Product Change Notification

Type of Notification: Changing of Input Current on the Product Name Label

FCA200F-□

Figure 2.1 Comparison between Before and After Changes

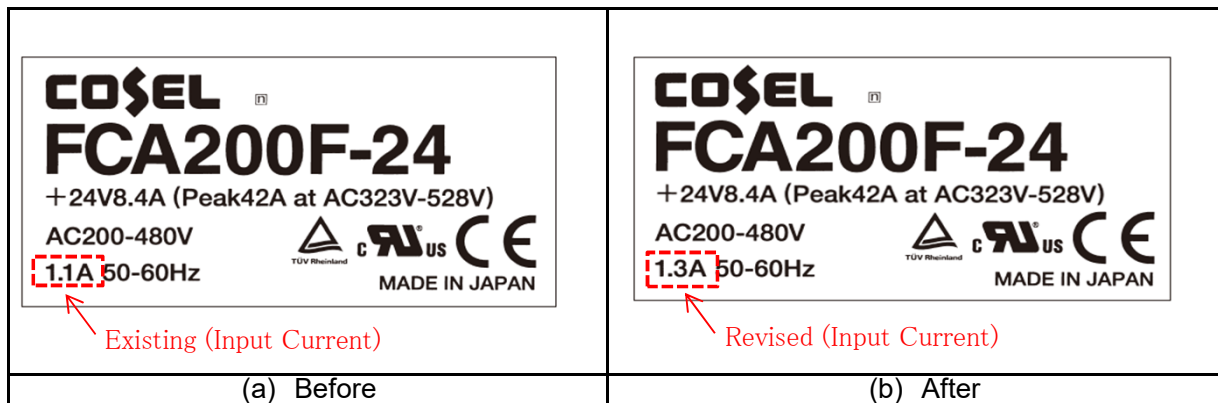
The IEC/EN60950-1 approved that FCA200F models have will change to IEC/EN62368-1 soon. The definition will also change regarding input current. So the labeled input current on the product name label will be changed as shown in Fig 2.1.

(a)The definition of existing IEC/EN60950-1:

Maximum input current value when the rated input voltage (between 240Vac to 480Vac).

(b)The definition of new IEC/EN62368-1:

Maximum input current value when the specification of input voltage (between 187Vac to 528Vac).
